Carolina Power & Light Company
Harris Nuclear Plant
PO Box 165
New Hill NC 27562

SHEARON HARRIS NUCLEAR POWER PLANT
DOCKET NO. 50-400/LICENSE NO. NPF-63
EMERGENCY ACTION LEVEL REVISION 00-1

HNP Emergency Action Level Flow Path Rev. 00-1 (Natural Phenomenon EAL change)

Change Comparison for EALs 9-1-2 and 9-1-3 (Seismic Events):

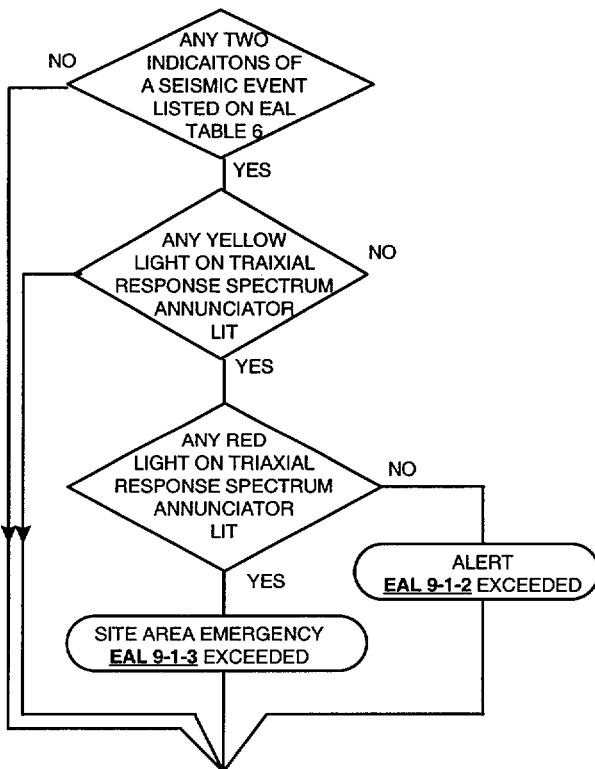
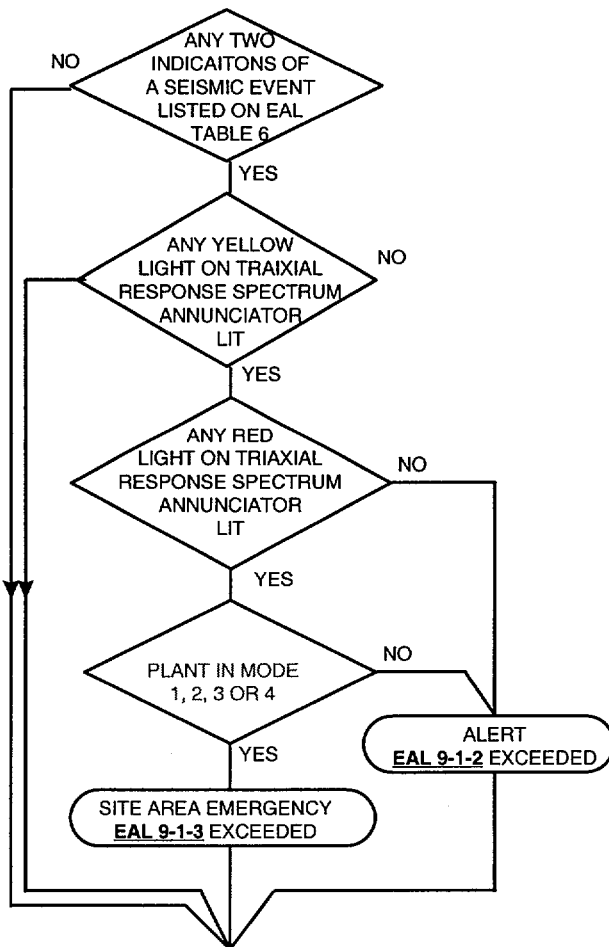
Change Assessment - EAL 9-1-3 Site Area Emergency associated with a seismic event:

The addition of a plant in Mode 1-4 requirement prior to escalating to a Site Area Emergency makes the HNP EALs consistent with NUREG-0654/FEMA-REP-1¹ and would result in escalation to a Site Area Emergency only for those events which meet the Class Description² and Purpose² of this classification level.

Change Comparison for Adverse Weather EALs (9-2-1/2/3 and 9-3-1/2/3):

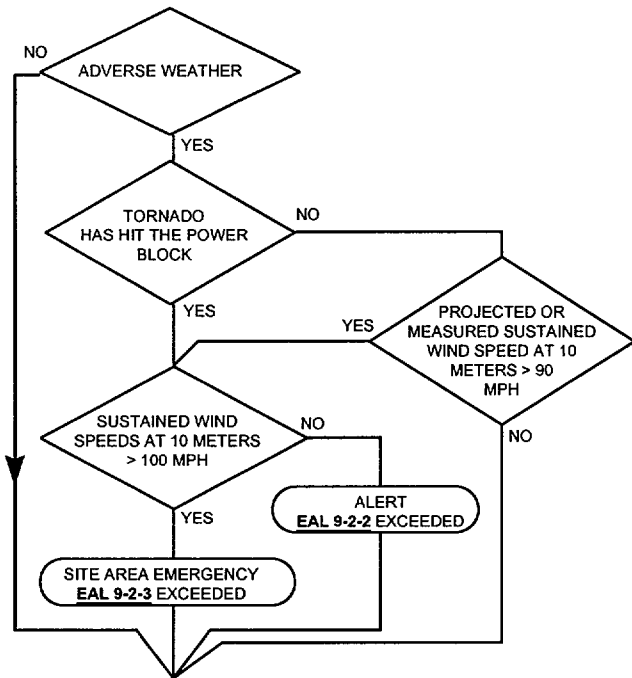
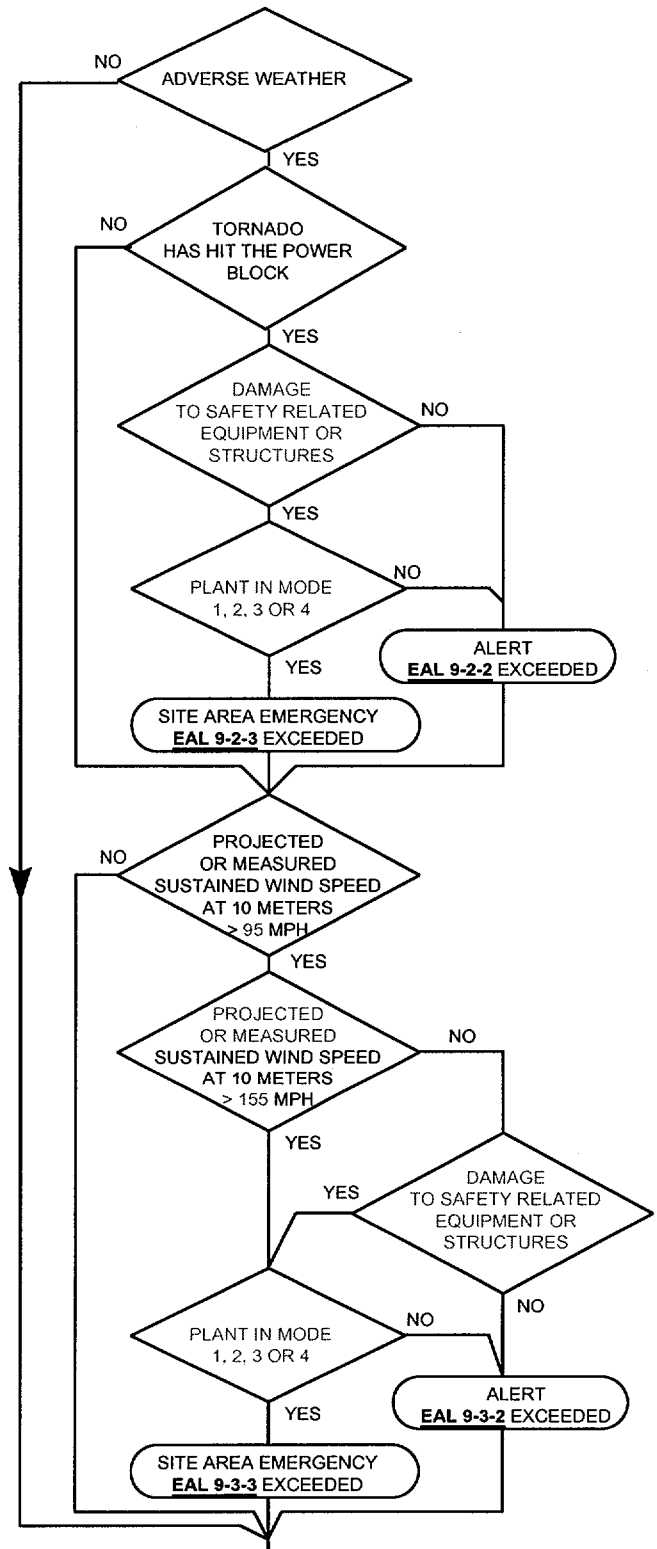
Change Assessment - EAL 9-2-3 Site Area Emergency associated with a tornado

1. The addition of a plant in Mode 1-4 requirement prior to escalating to a Site Area Emergency is consistent with NUREG-0654/FEMA-REP-1³.
2. The previous use of a >100 MPH sustained wind speeds criteria for escalation has been replaced by assessment of any damage occurring as a result of the tornado. The intent of both the previous and current assessments is to determine if the event exceeds design levels. The change in criteria is appropriate based on:

- Plant meteorological tower location (approx. 1.1 miles northeast of the Protected Area) would be of limited value in evaluating wind conditions in the area around a tornado impacting the Protected Area.

3. The decision blocks were rearranged with hurricane and tornado related assessments being separated for clarity and to ensure proper human factors considerations with incorporation of the above modifications.

Change Assessment - EAL 9-3-3 Site Area Emergency associated with hurricane force winds

1. The addition of a plant in Mode 1-4 requirement prior to escalating to a Site Area Emergency is consistent with NUREG-0654/FEMA-REP-1 ⁵.
2. The change of the threshold 10 meter wind velocity from 100 MPH to 155 MPH remains conservative with regard to the NUREG-0654/FEMA-REP-1 basis (179 MPH ⁶) for this EAL and provides for enhanced ability to predict and monitor the threshold for this condition ⁷.

3. An additional criteria for escalation to a Site Area Emergency has been added for conditions not meeting the wind speed threshold, but still resulted in damage to safety related equipment or structures. Presence of this damage would be indicative of weather effects which "exceeded design levels." This addition provides for consistency in assessment of EALs associated with high sustained winds (hurricane force) and tornado effects on the plant.

4. The decision blocks were rearranged with hurricane and tornado related assessments being separated for clarity and to ensure proper human factors considerations with incorporation of the above modifications.

Change Assessment - EAL 9-3-2 Alert associated with hurricane force winds

1. The change of the threshold 10 meter wind velocity from >90 MPH to >95 MPH remains conservative with regard to the NUREG-0654/FEMA-REP-1⁸ basis (179 MPH⁹) for this EAL and provides for enhanced ability to predict and monitor the threshold for this condition¹⁰.
2. The decision blocks were rearranged with hurricane and tornado related assessments being separated for clarity and to ensure proper human factors considerations with incorporation of the above modifications.
